UNITED STATES PATENT AND TRADEMARK OFFICE

Office Action Summary	Application No. 10/579,362	Applicant(s) NIEMCZYK, ANDREW	
	Examiner JESSIE FONSECA	Art Unit 3633

DETAILED ACTION

Fig. 2: Rose (US 5,248,225)

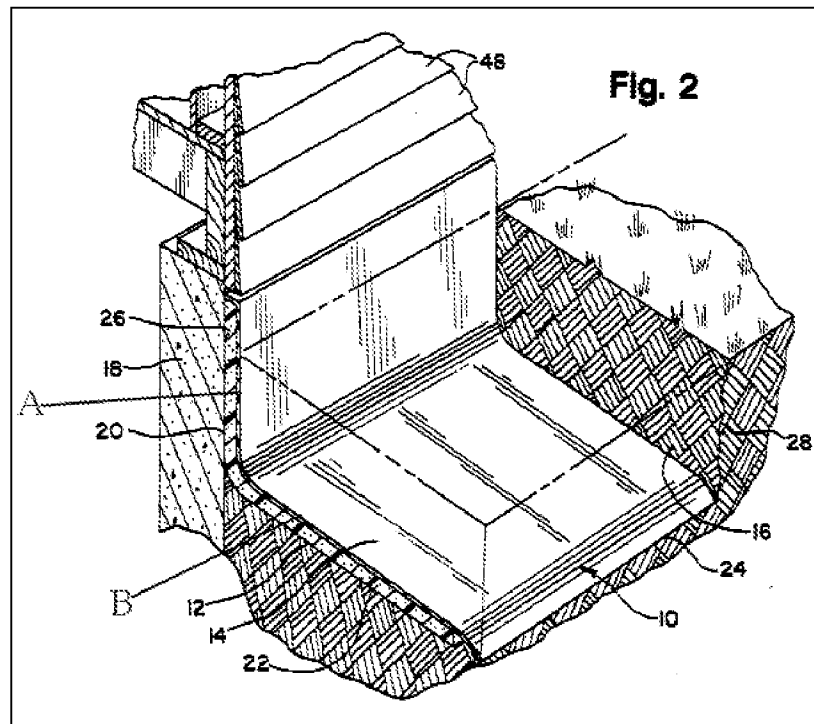
With regard to claim 1: Rose discloses a water protection system (figs. 3-5) capable of use in with a basement wall characterized by:

at least one water impermeable flexible member having a short leg section (A) and a long leg section (B) (figs. 3-5; col. 5, lines 17-22).

The short leg section of Rose is capable of being abutted against an upper portion of basement wall so that the long leg section extends substantially away from the basement wall a distance at least as great as the tangent of 15° times the height of the basement wall below the water impermeable flexible member.

With regard to claim 4: Rose discloses a basement wall water protection system characterized by:

a plurality of semi-flexible water impermeable overlapping plate members (14);
each plate member having a short leg section (A) and a long leg section (B); and

each of said plate members (14) having a first side edge and a second complementary side edge such that a first side edge of one plate member can join with said second side edge of a second plate member (14) to form a watertight joint (fig. 5; col. 6, lines 49-52).

The short leg section of Rose is capable of being abutted against an upper portion of basement wall so that the long leg section extends substantially away from

the basement wall a distance at least as great as the tangent of 15° times the height of the basement wall below the water impermeable flexible plate member member.

With regard to claim 9: Rose further discloses the long leg extending away from the foundation at approximately at a downward slope of 1 inch per 12 inch away from the foundation (col. 5, lines 32 -35), which Examiner submits is approximately a 5° slope. Given the slope disclosed by Rose, the angled sloped can be calculated as shown below.
